Miscellaneous:

Shortage of electric compressors for auxiliary cab cooler

444 536

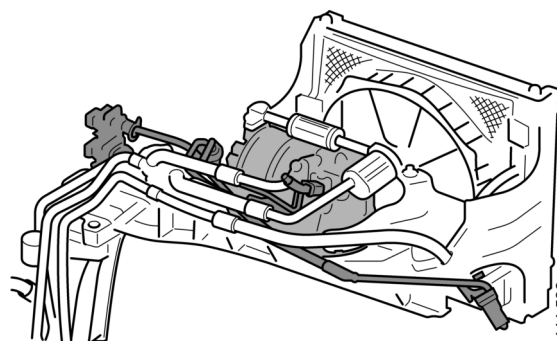
Some vehicles will be fitted with a dummy instead of an auxiliary cab cooler. There will be a red tag on the dummy with the text *Not intended for production*.

On vehicles produced with the correct compressor, spare part programming for SDP3 needs to be carried out.

Vehicles with a dummy will need to be supplemented with a compressor in an upcoming campaign as soon as parts are available.
